Access Compliance Report

Public Rights-of-Way

(Pedestrian Signals)

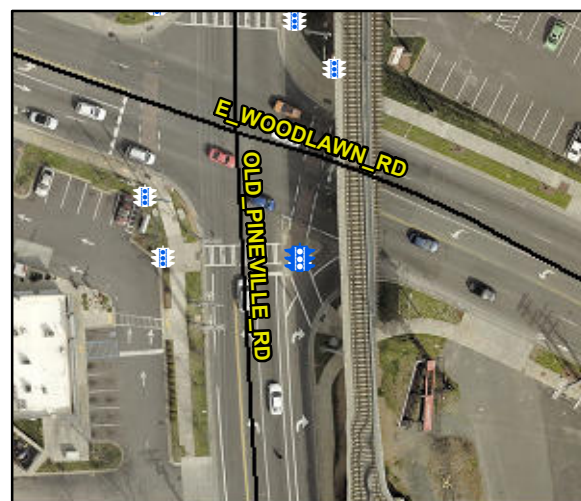
PROW/ADA: TMUTCD 4e.08, R404.7.1, R404.7.2, , R406.2, R404.7.3

Compliance	Description	Data	Compliance	Description	Data
	Button Count	Button2	N/A	Distant to Additional Button (in)	N/A
	Additional Button Present?	No		Additional Button ID	N/A
N/A	Signal Buttons Required?	N/A	N/A	Additional Ped Posts Required	N/A
	How Many Ped Street Xings?	3		Located In An Island/Median?	Yes
N/A	B 1 Sign Present?	Yes	N/A	B 2 Sign Present?	Yes
Yes	B 1 Sign Purpose?	Yes	Yes	B 2 Sign Purpose?	Yes
Yes	B 1 Sign Lettering & Contrast?	Yes	Yes	B 2 Sign Lettering & Contrast?	Yes
Yes	B 1 Parallel To XWalk?	Yes	Yes	B 2 Parallel To XWalk?	Yes
Yes	B 1 PAR to Button?	Yes	Yes	B 2 PAR to Button?	Yes
Yes	B 1 PAR to XWalk?	Yes	Yes	B 2 PAR to XWalk?	Yes
Yes	B 1 Clear Floor Space?	Yes	Yes	B 2 Clear Floor Space?	Yes
No	B 1 FWD Approach?	No	N/A	B 2 FWD Approach?	Yes
N/A	B 1 FWD Approach Constrained?	N/A	N/A	B 2 FWD Approach Constrained?	No
N/A	B 1 FWD Approach Reach (in)	N/A	No	B 2 FWD Approach Reach (in)	11.0

N/A	B 1 FWD Approach Width (in)	N/A	N/A	B 2 FWD Approach Width (in)	N/A
N/A	B 1 FWD Approach Obstruction?	N/A	N/A	B 2 FWD Approach Obstruction?	Yes
N/A	B 1 FWD Approach Obstruction Dist (in)	N/A	N/A	B 2 FWD Approach ObstructionDist (in)	10.0
No	B 1 PARA Approach?	No	N/A	B 2 PARA Approach?	Yes
N/A	B 1 PARA Approach Constrained?	No	N/A	B 2 PARA Approach Constrained?	No
N/A	B 1 PARA Approach Reach (in)	17.0	No	B 2 PARA Approach Reach (in)	11.0
N/A	B 1 PARA Approach Width (in)	N/A	N/A	B 2 PARA Approach Width (in)	N/A
N/A	B 1 PARA Approach Obstruction?	Yes	N/A	B 2 PARA Approach Obstruction?	Yes
N/A	B 1 PARA Approach Obstruction Dist (in)	9.0	N/A	B 2 PARA Approach ObstructionDist (in)	10.0
Yes	B 1 Clear Floor Space Slope (%)	1.9	Yes	B 2 Clear Floor Space Slope (%)	2.6
Yes	B 1 Clear Floor Space XSlope (%)	1.2	Yes	B 2 Clear Floor Space XSlope (%)	0.7
N/A	B 1 PAR Slope (%)	3.0	N/A	B 2 PAR Slope (%)	3.1
Yes	B 1 Height (in)	35.0	Yes	B 2 Height (in)	35.0

Yes B 1 Clear Xing Direction?	ClearlyMarked	Yes B 2 Clear Xing Direction?	ClearlyMarked
B 1 Crossing Direction	To W	B 2 Crossing Direction	To NE
Yes B 1 DistanceTo XWalk (in)	0.0	Yes B 2 DistanceTo XWalk (in)	0.0
No B 1 DistanceTo Curb (in)	143.0	No B 2 DistanceTo Curb (in)	99.0
Yes B 1 Diameter (in)	2.0	Yes B 2 Diameter (in)	2.0

Possible Solutions: Replace Signal Push Button With APS Button on New Post. Remove & Relocate Sign.
